ACCESSORY KIT NO. AK-119B (Supersedes AK-119A)

SHOULDER HARNESS ACCESSORY KIT

AA1-0001 through AA1-0432

FIGURE 1.

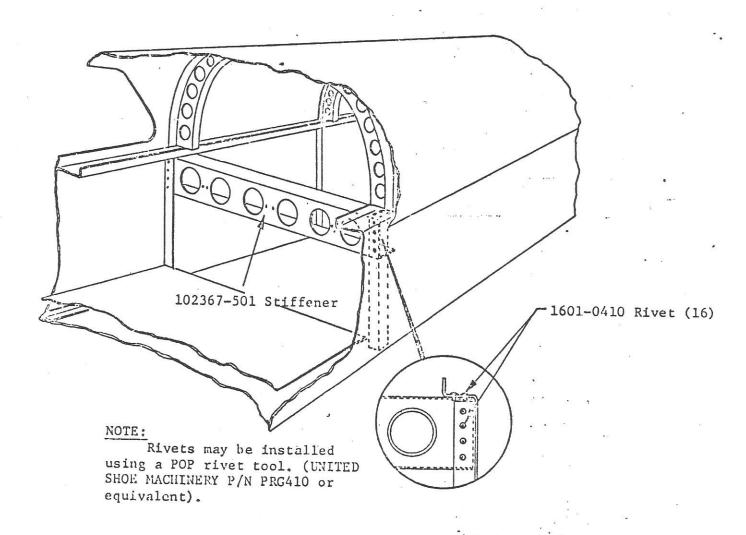
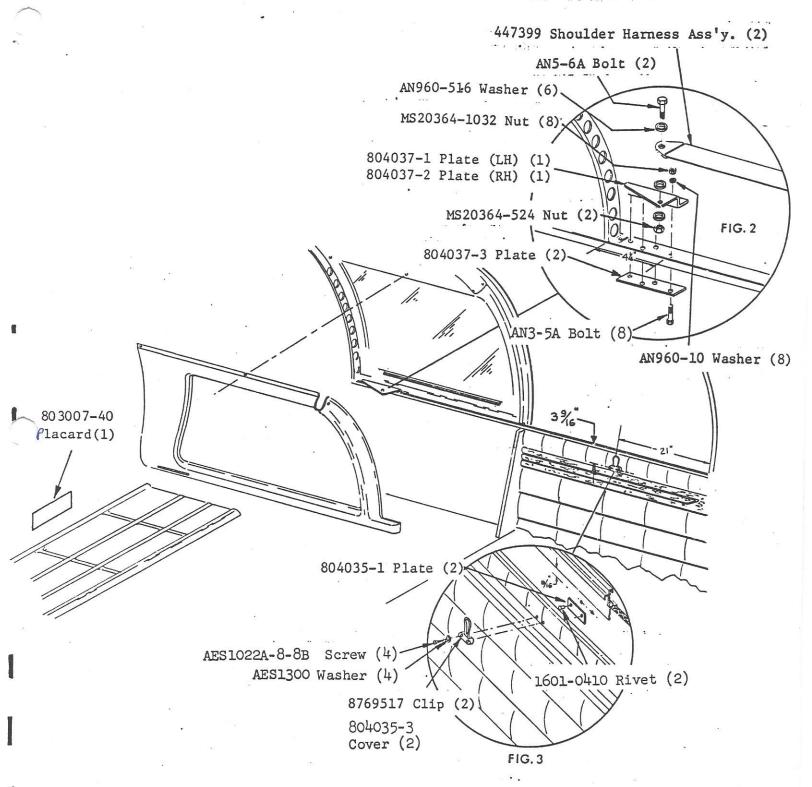
NOTE: REV. "B" CHANGES AES1022A-8-8 SCREW TO AES1022A-8-8B SCREW (4) AND 804035-2 PLACARD (1) TO -40 PLACARD (1). ADDED 804035-3 COVER (2). RIVET QUANTITY WAS (4) IS NOW (2). AN3-4A BOLT IS AN3-5A BOLT (8). AES 1300 WASHER REPLACES A3135-017-24A (4).
